Statesville Moose Lodge

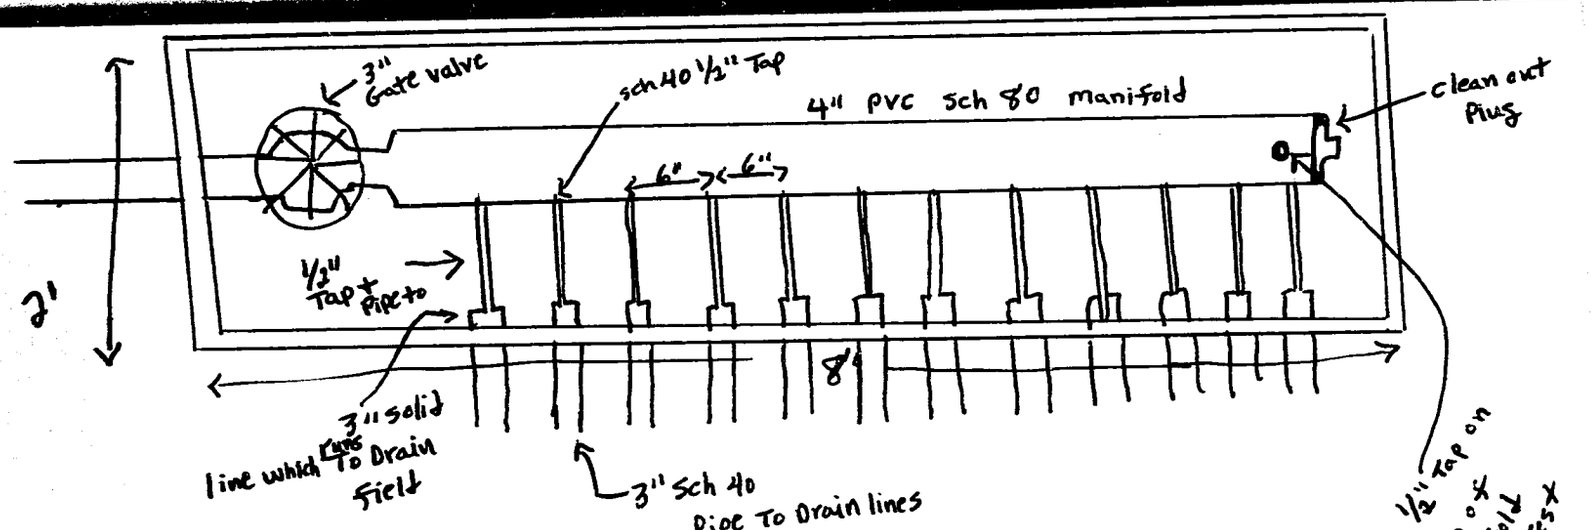
Lids on 60X must be easily removeable + weather tight

Top of 60X must 6" above finish Grade of Landscape

Detail on manifold 60X + manifold
